**Millstone Nuclear Power Station, Unit No. 3  
Response to Request for Additional Information,  
Spent Fuel Pool Rerack (TAC No. MA5137)**

**Response to Request for Additional Information  
Spent Fuel Pool Rerack (TAC No. MA5137)**

Response to Request for Additional Information  
Spent Fuel Pool Rerack (TAC No. MA5137)  
Additional Questions Regarding Heavy Load Handling

**Additional Questions Regarding Heavy Load Handling  
Rigging Configurations - Exhibits 6.5.1 through 6.5.5**

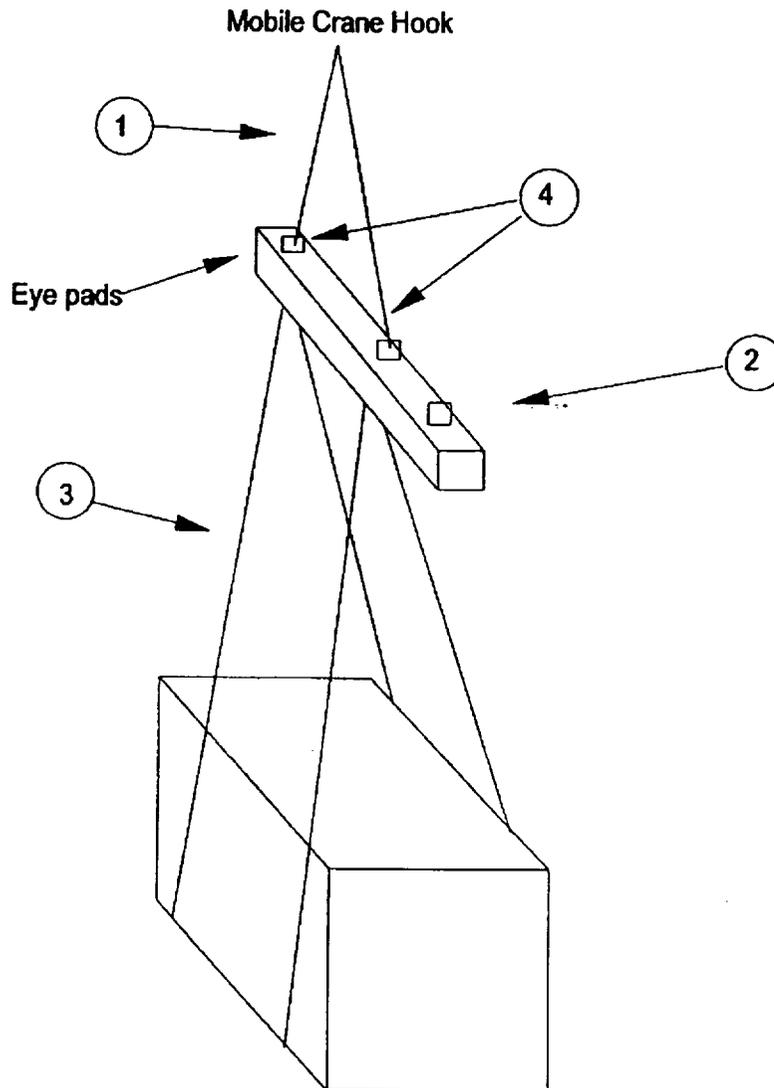
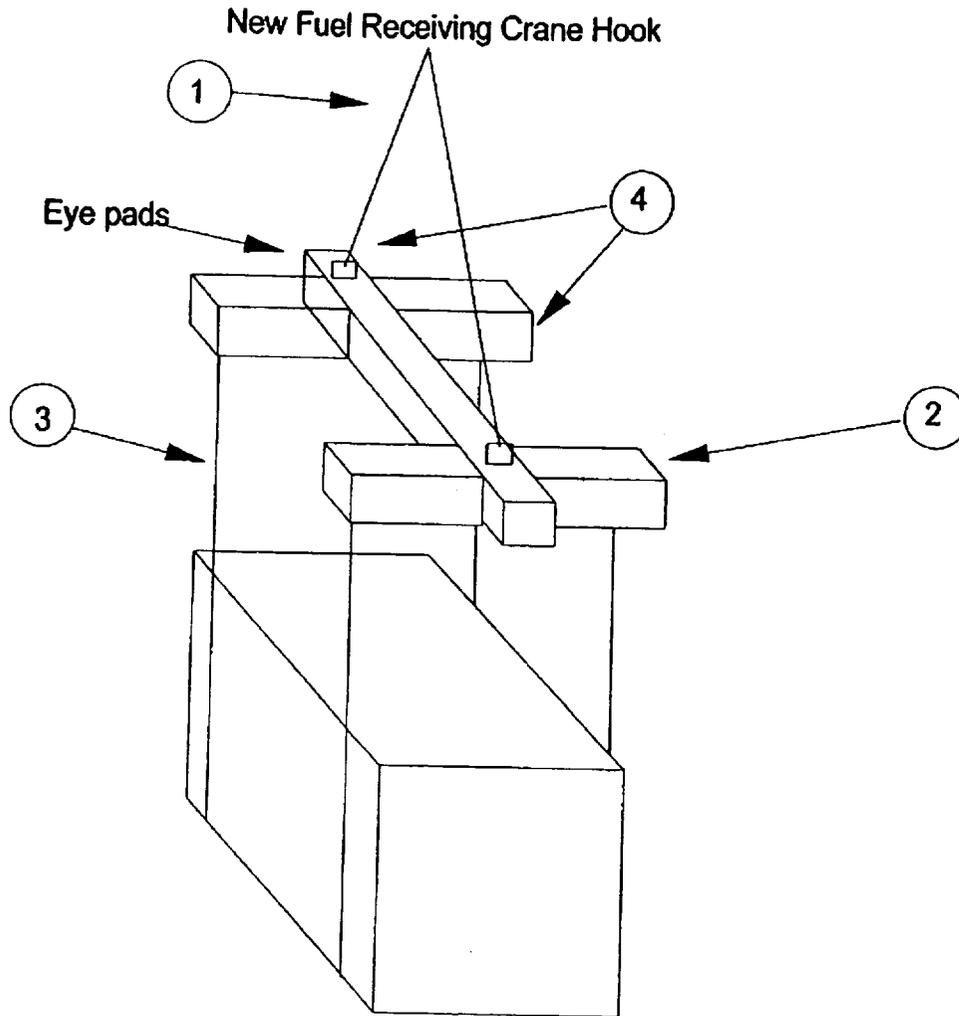
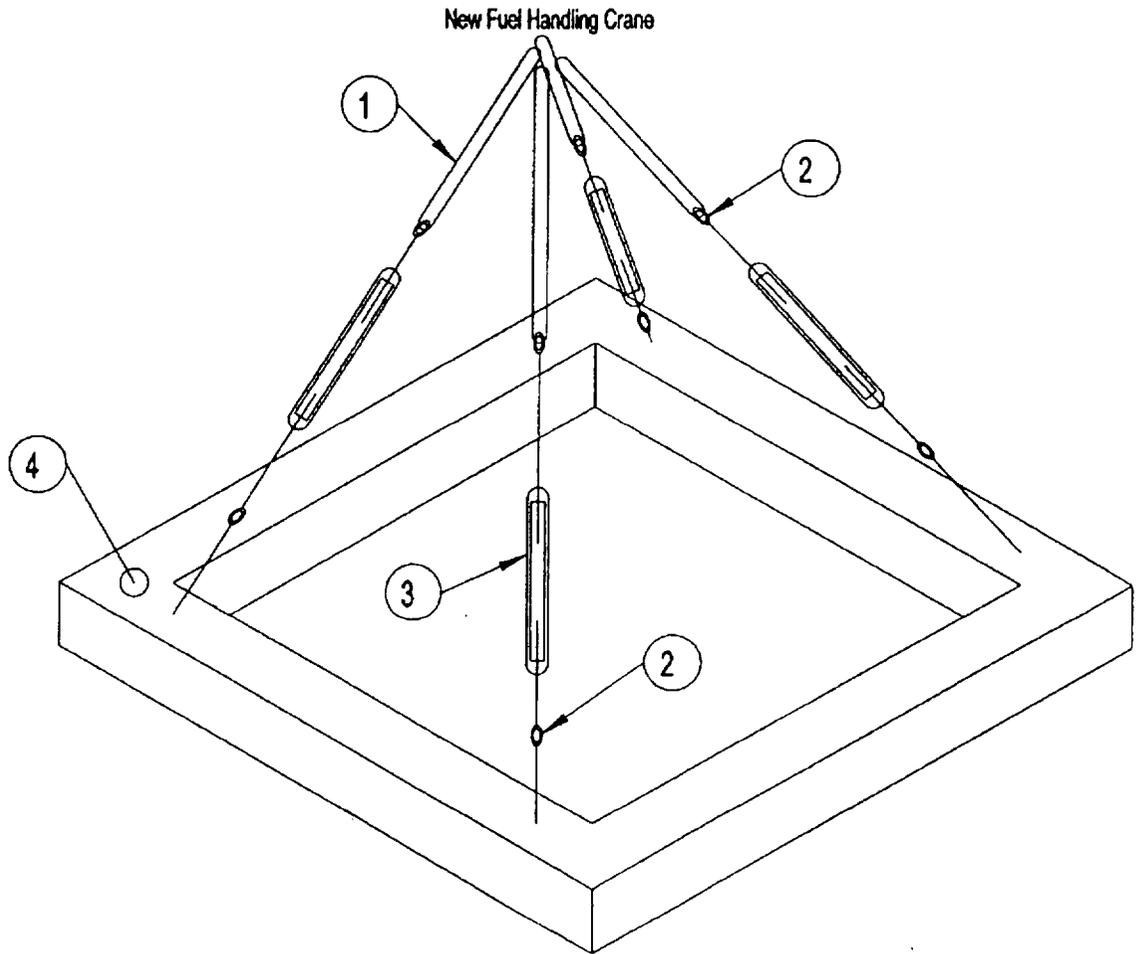
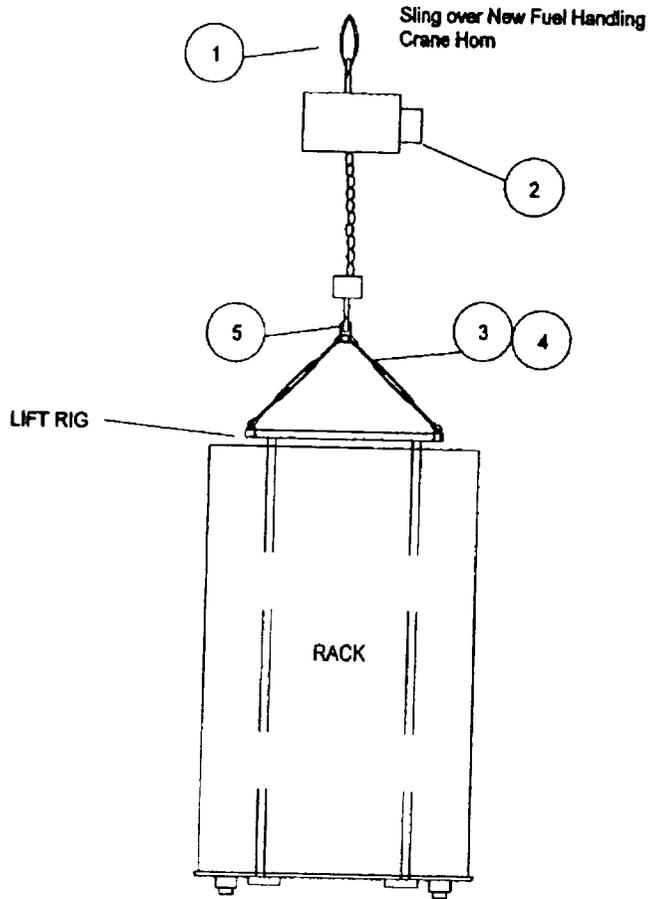
- 1. Regarding lifting devices described in Section 3.3 of the Holtec Licensing Report, provide additional detail with respect to the use of installed equipment and its interface with vendor supplied lifting devices, and the design and qualification standards applied to vendor supplied lifting devices.**

**5. Clarify item 5 of Table 3.5 regarding use of “non-customer” lifting devices.**

Information related to vendor supplied lifting rigs is provided in Section 3.3 of Attachment 5 to the March 19, 1999,<sup>(1)</sup> submittal. Further details are provided herein as Enclosure 1, which contains five figures depicting the rigging arrangements to be used in handling the storage rack assemblies. These figures are excerpted from the NNECO approved Millstone Vendor Procedure entitled "Onsite Handling & Installation Procedure" to be used by Holtec, and are identified as Exhibits 6.5.1 through 6.5.5. Additional information regarding the required ratings of the components to be utilized is also provided on these figures.

The reference in this entry is to vendor supplied lifting devices. These lifting devices are depicted on the figures provided as Enclosure 1 to this submittal.

## EXHIBIT 6.5.3 RIGGING CONFIGURATION FOR RACK UPENDING

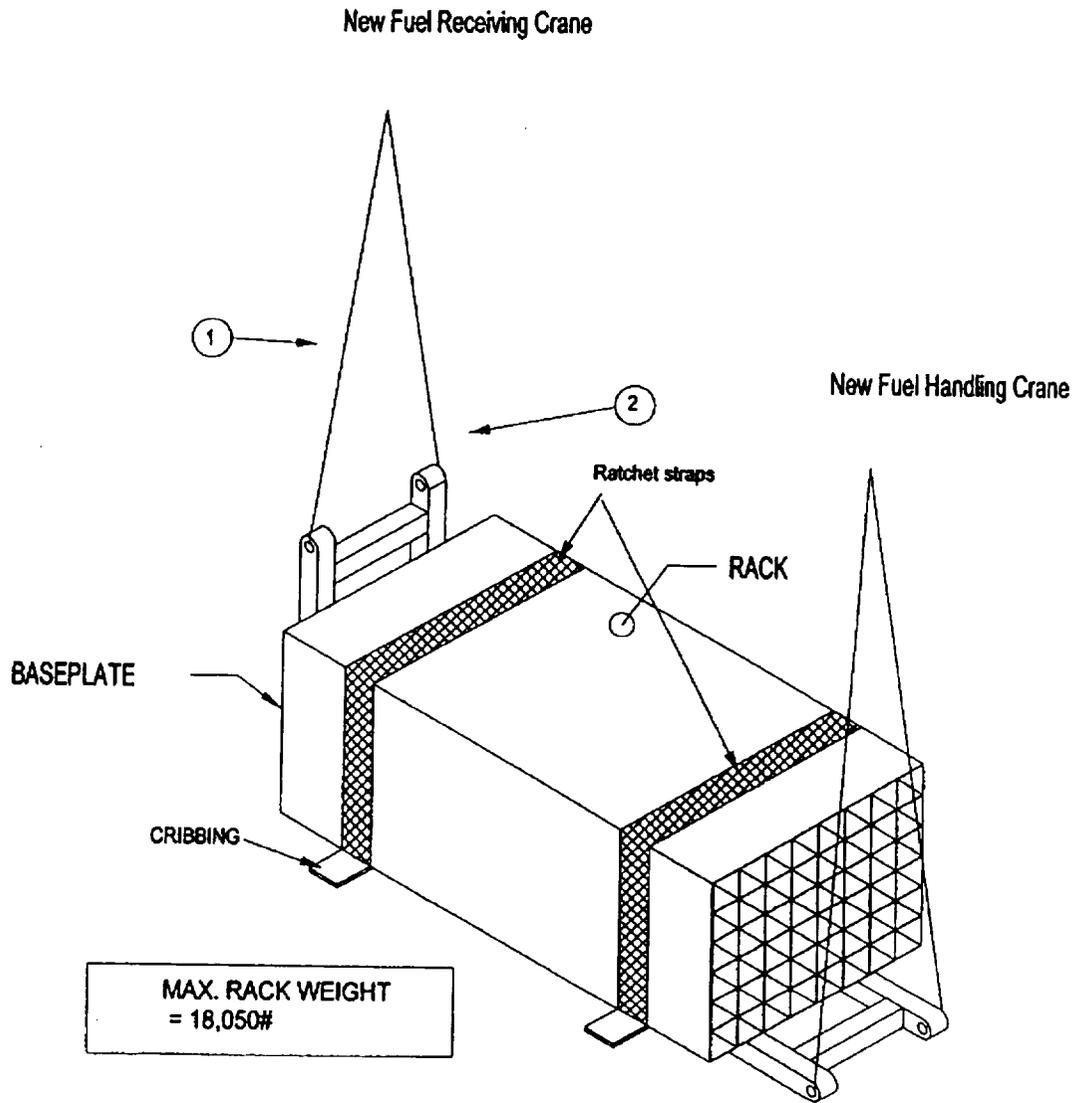
**6. Clarify the discussion at the beginning of Section 10.5 of the Holtec Licensing Report regarding upending operations.**

The Exhibit 6.5.3 of Enclosure 1 illustrates the rigging arrangement for the upending process as well as the designated cranes to be used in this process.
